Backfeed v212

145.3.8.8 Backfeed Reflected voltage

Figure 145–29a — Reflected voltage requirements

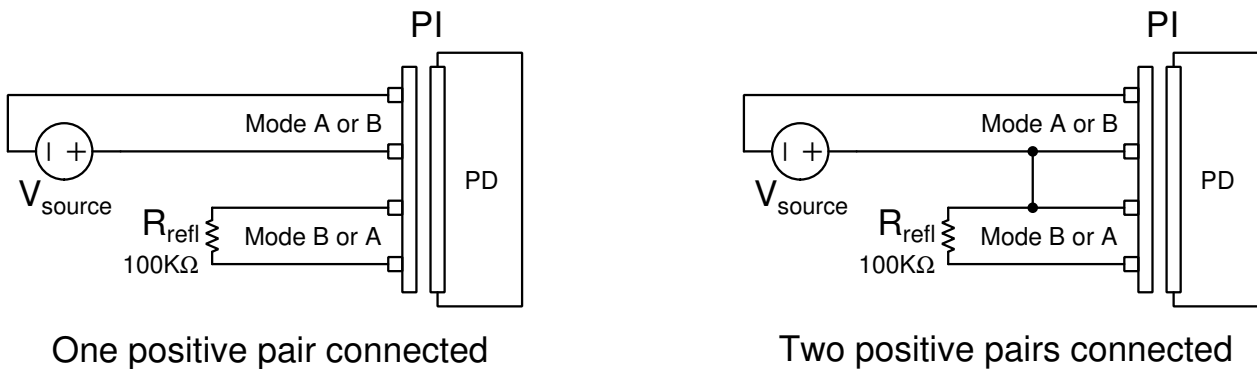
For a single-signature PD, when any voltage in the range of 0 V to $V_{Port_PD-2P\ max}$ is applied per any of the valid 2-pair configurations, defined in Table 145–20, that have only a single pair connected to positive V_{PSE} (see Figure 145–29a), the voltage on the Mode not connected to the voltage source, with a 100 k Ω resistor connected across that Mode, shall not exceed V_{refl} as defined in Table 145–29.

For a single-signature PD, when any voltage in the range of 0 V to 10.1 V is applied per any of the valid 2-pair configurations, defined in Table 145–20, including those with two pairs connected to positive V_{PSE} (see Figure 145–29a), the voltage on the Mode with at least one pair not connected to the voltage source, with a 100 k Ω resistor connected across that Mode, shall not exceed V_{refl} as defined in Table 145–29.

For a dual-signature PD, when any voltage in the range of 0 V to $V_{Port_PD-2P\ max}$ is applied per any of the valid 2-pair configurations, defined in Table 145–20, including those with two pairs connected to positive V_{PSE} (see Figure 145–29a), the voltage on the Mode with at least one pair not connected to the voltage source, with a 100 k Ω resistor connected across that Mode, shall not exceed V_{refl} as defined in Table 145–29.
